**ALERT SERVICE BULLETIN**

REVISION NOTICE

**SUBJECT: REVISION "A" TO ALERT SERVICE BULLETIN 212-00-110: FIN SPAR  
CAP P/N 212-030-125-001, P/N 212-030-447-001/101, INSPECTION OF**

Revision "A" to this bulletin increases the initial compliance period and clarifies it with the use of a table. The description is also more detailed to help operators differentiate between the different possible configurations.

FIGURE 3. (SHEET 1 OF 2) - PART II: INSPECTION CONFIGURATION FOR 212-030-125-001 W/ RETROFIT KIT 212-704-087

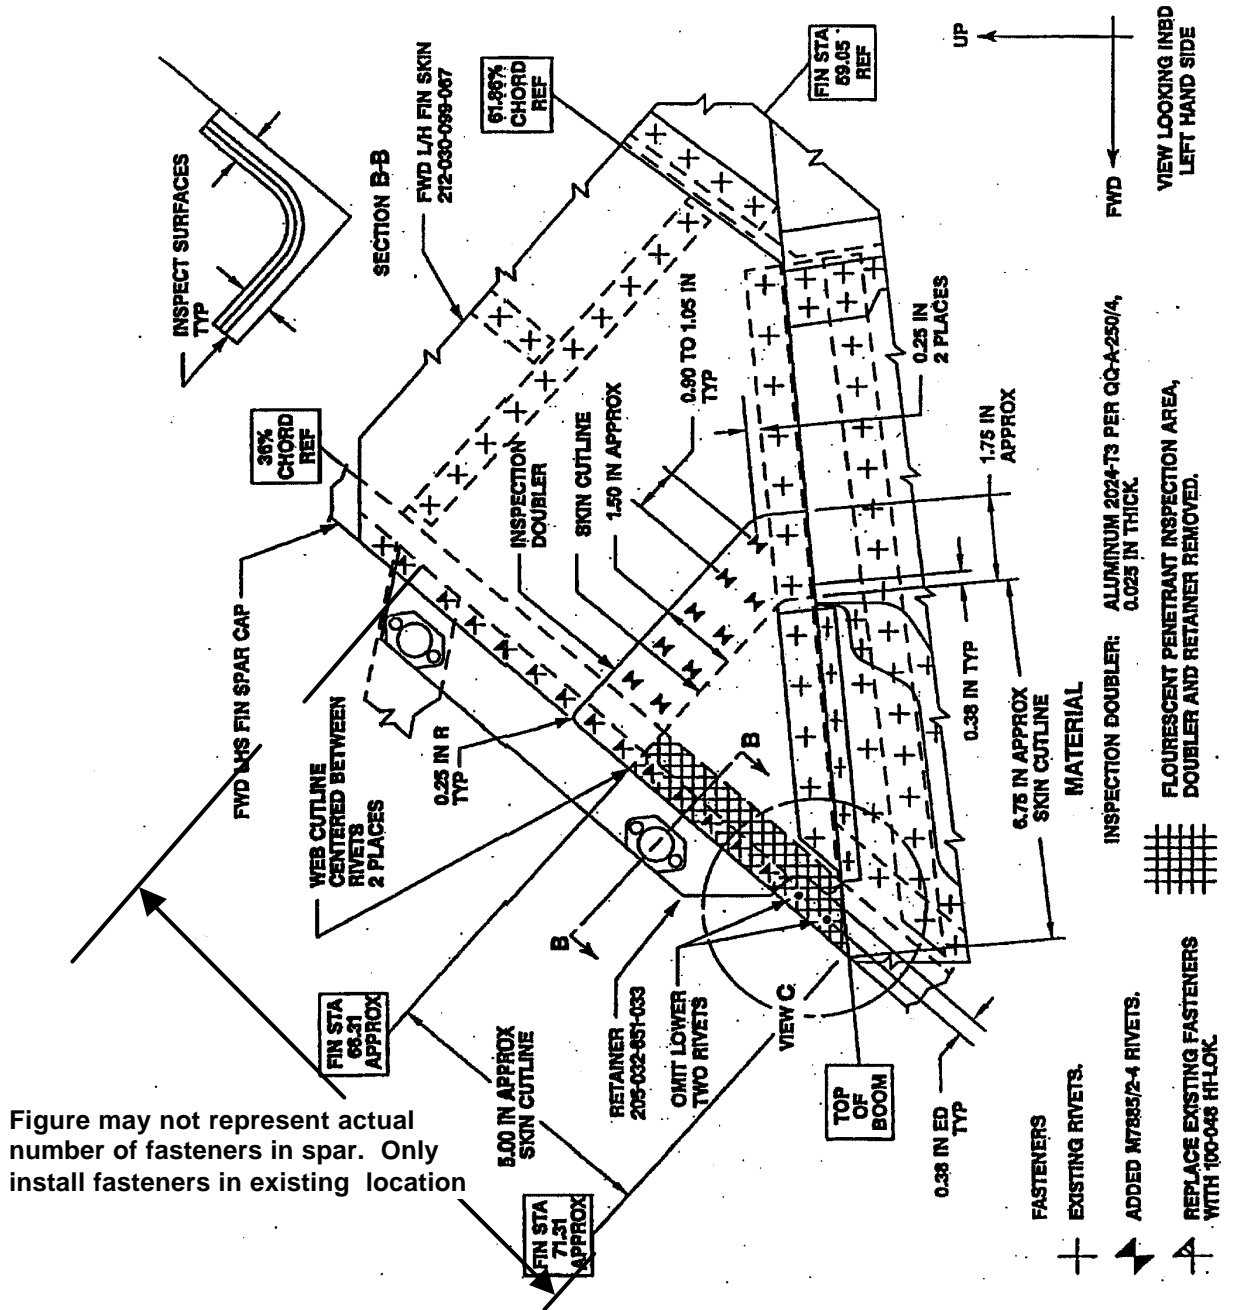
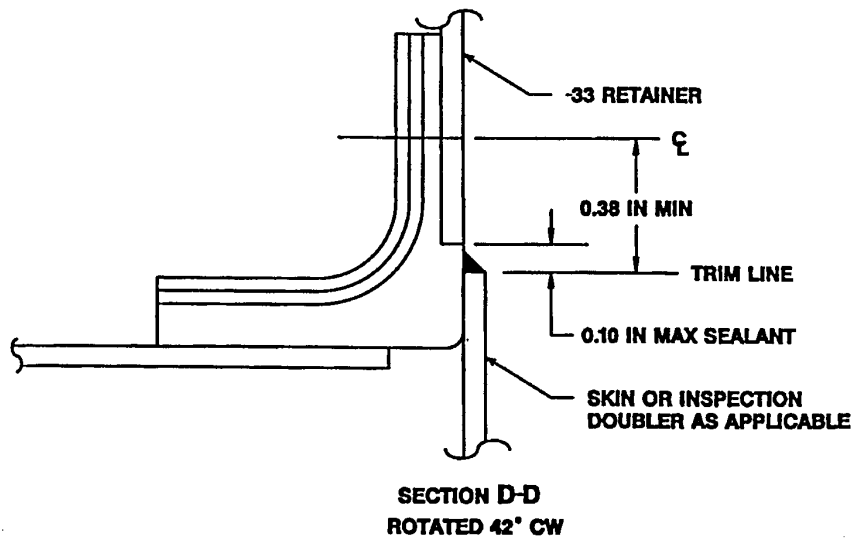
2. For P/N 212-030-447-101, remove Clip P/N 212-030-099-091 and Radius Block P/N 212-030-099-095, if existing. Remove sufficient rivets from the bottom row of the FWD L/H Fin Skin and from the P/N 212-030-121-037 Retainer and Spar Cap, to allow trimming of the FWD L/H Fin Skin as shown by the crosshatched area of Figure 2, View C. For P/N 212-030-125-001 with Retrofit Kit P/N 212-704-087, remove Clip P/N 212-030-099-091 and Radius Block P/N 212-030-099-095, if existing. Remove sufficient rivets from the bottom row of the FWD L/H Skin and from the P/N 212-030-121-033 Retainer and Spar Cap, to allow trimming of the FWD L/H Fin Skin and P/N 212-030-121-033 retainer, as shown by the crosshatched area and the skin cutlines Fin 66.31 to 71.31 of Figure 3, View C.

3. Do not use chemical paint strippers. Mask off area to be stripped and cleaned. Using Scotch-Brite TY-A (very fine) (C-407) and MEK, remove paint and primer locally 0.38 inch maximum from around the two lower rivet holes on the cap flange outboard surface (see Figure 2 or 3). Deburr holes in the spar where rivets were removed.

8. Fasten the FWD L/H Fin Skin and the P/N 212-030-121-037 or P/N 212-030-121-033 Retainer back to the spar assembly using Hi-Loks and blind rivets as shown in Figure 2 or Figure 3. Reinstall Clip and Radius Block (if existing) removed in item 2.
9. Refinish reworked area as per instructions found in Standard Repair Manual except in area where protective coat of MIL-C-16173, Grade 2 was used.
10. Install the inspection door, intermediate gearbox cover and tail rotor driveshaft cover.
11. Make an entry in helicopter historical records indicating compliance with this bulletin.

2. Remove the P/N 212-030-099-091 Clip and P/N 212-030-099-095 Radius Block, if existing. Remove the P/N 212-030-121-037 or P/N 212-030-121-033 Retainer and sufficient rivets from the bottom row of the FWD L/H Fin Skin to allow trimming of the FWD L/H Fin Skin along the "skin cutline", approximately Fin Station 66.31. See Figure 2 or 3.

3. Do not use chemical paint strippers. Mask off area to be stripped and cleaned. Using Scotch-Brite, TY-A (very fine)(C407) and MEK, remove paint and primer in the crosshatched area shown in Figure 2 or 3 (Sheet 1).

5. If facility and/or personnel are not approved to perform a fluorescent penetrant inspection, proceed to Item 7.
6. Carry out the fluorescent penetrant inspection of the area shown in Figure 2 or 3 using the procedure stated in the Standard Practices Manual, BHT-ALL-SPM, Chapter 6.2. Proceed to Item 8.

FIGURE 3. (SHEET 2 OF 2) - PART II INSPECTION CONFIGURATION FOR 212-030-125-001 W/ RETROFIT KIT 212-704-087

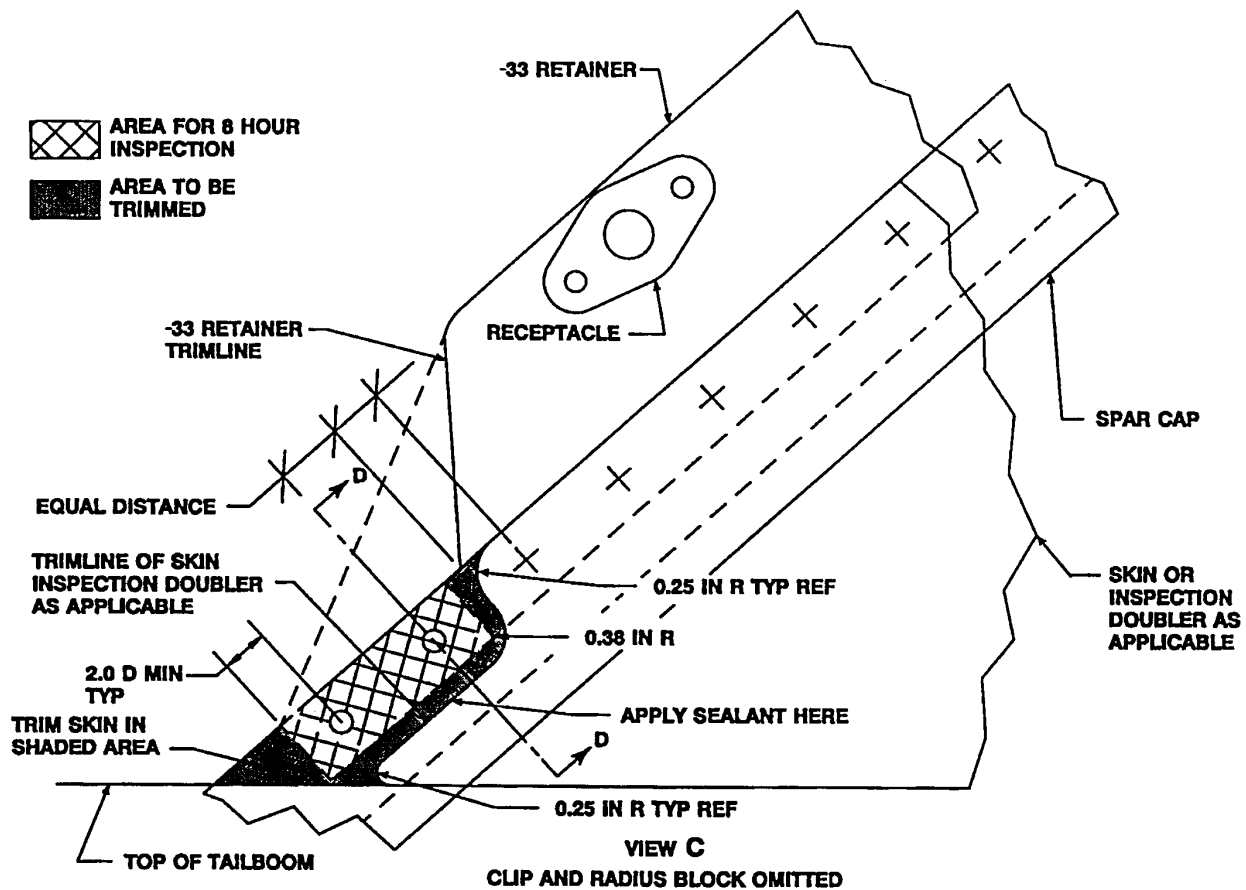
11. After inspection, mask off area designated for 8-hour inspections, reference Figure 2 (Sheet 2) or Figure 3 (Sheet 2) and apply unreduced zinc chromate primer, TT-P-1757, to the remaining bare surface. When dry, remove masking and apply MIL-PRF-81352 clear lacquer to the crosshatched area shown in
